WRN1 - Check Rear Axle Drive and Replace if Necessary (Stop Delivery)

Vehicle Type: **Macan 4 (XAB)**

Model Year: **2024**

Concerns: **Rear-axle final drive**

Installation position of rear-axle final drive

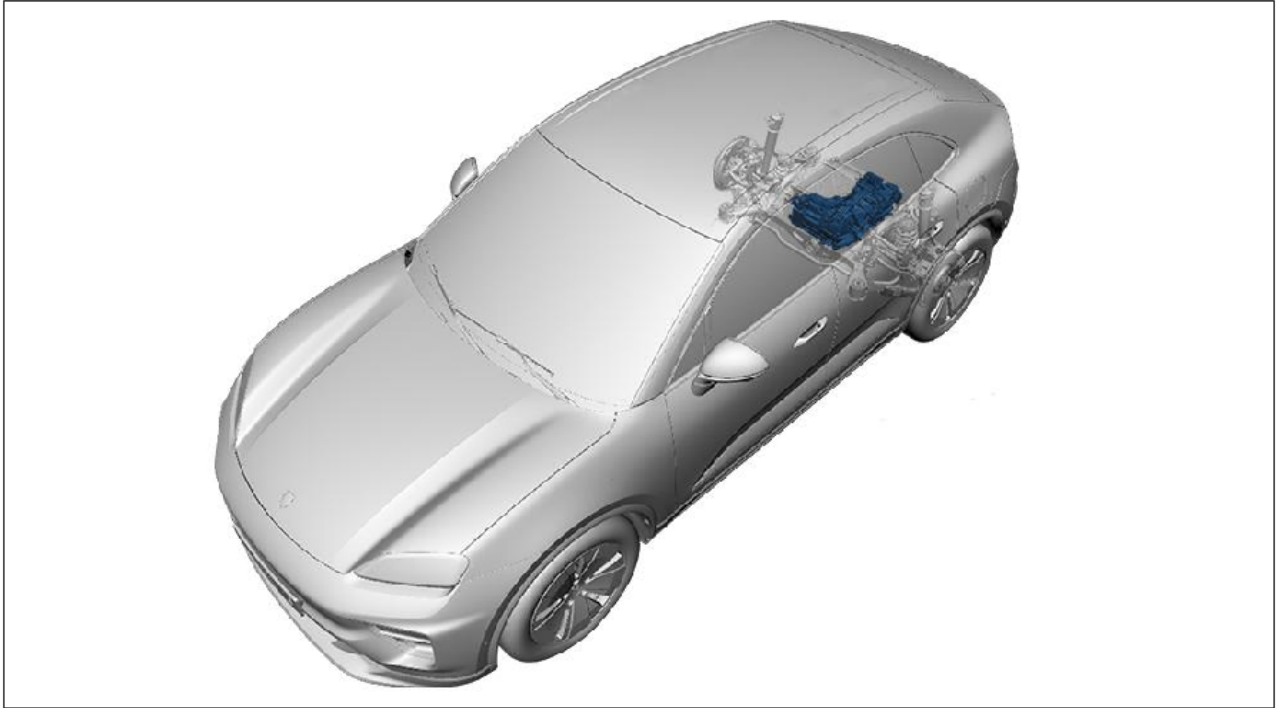
Cause: **There is a possibility that a rear axle final drive was installed in the affected vehicles, that does not meet the required specifications.**

If this is the case, damage to the final drive and subsequent mechanical noises as well as loss of drive on the rear axle cannot be ruled out when driving dynamically.

Action: Check rear axle final drive and replace if necessary.
